**ENVIRONMENTAL COMPLIANCE & AREA COMPLETION PROJECTS (EC&ACP) STANDARD
OPERATING PROCEDURES, VOL. I**
Manual: C3
Procedure: ER-IDS-019-063
Revision: 3
Effective Date: 10/25/2016
Type-Class: Form
Page: 1 of 2

**R-AREA OPERABLE UNIT REACTOR BUILDING AND DISASSEMBLY BASIN FIELD INSPECTION
CHECKLIST**

R-Area Operable Unit Reactor Building and Disassembly Basin

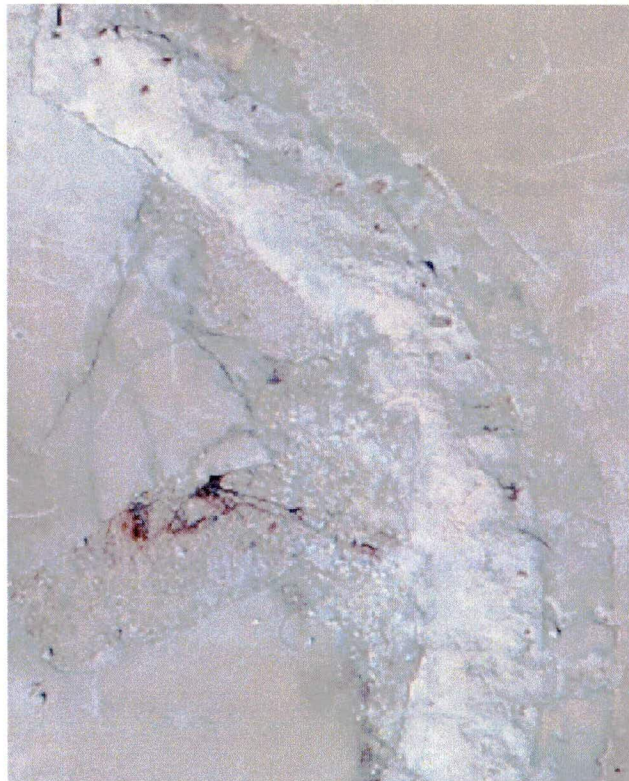
NOTES: (1) CARRY OVER ITEM: Vegetation growing on roofs. ACP will develop a work package to remove vegetation as well as remove silt, sand and debris from roofs. (2) = ACP will develop a work package to repair caulk joints on the disassembly basin cover. (3) = Area of concrete spalling.
 SEE ATTACHED FOR CTF REVIEW & COMMENTS

Condition of the roofs remained the same since last inspection. There was no further deterioration at the edge of concrete roof were stack was located. Vegetation growth is present at various areas on the roof. The sediment should be removed to eliminate and prevent vegetation. Some spots exist on the roof that cause the potential for pooling water. Spalled concrete was identified on the west corners of the +88.25 roof, attached is the design engineering report. Please see pictures for further details.

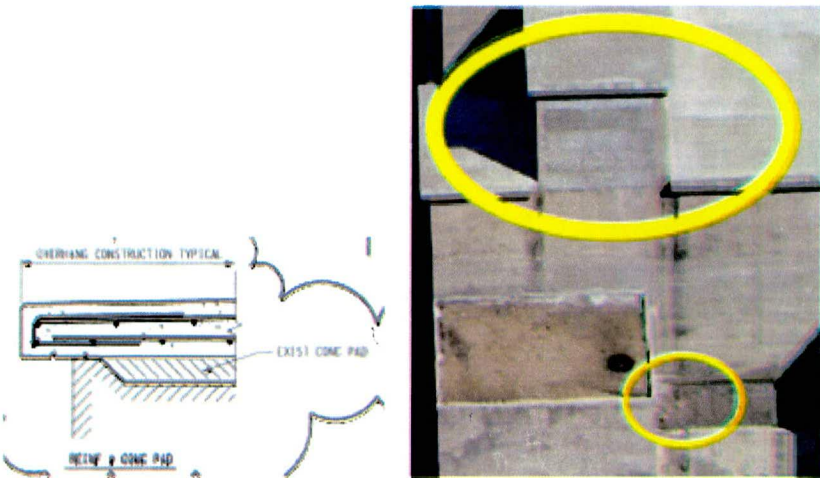
Bill,
From our conversations, it appears these spalls on the west corners of the El. 88.25 roof happened some time ago for unknown causes, probably soon after or during the activity of stripping the forms in 2011. It is noted from the aerial photo that some of the concrete shards landed harmlessly on the roof below and are still there.

Review of the drawing C-CC-R-00019, Sections F and H show the cap to be well reinforced with #6@18" each way and each face with "U-bars" for the cantilever load which is slightly increased by the spall of the corners below the roof slab. The spalled concrete is from the unreinforced concrete cover at the corner of the non-structural concrete curbs. The curbs are considered non-structural in the sense they do not contribute to the structural strength of the building. Given that the cap slab corner strength is undiminished by the spalls and the unreinforced concrete curb corners do not contribute to the overall strength of the building, this is considered an issue to put on the watch list for future deterioration, but not in need of immediate repair.
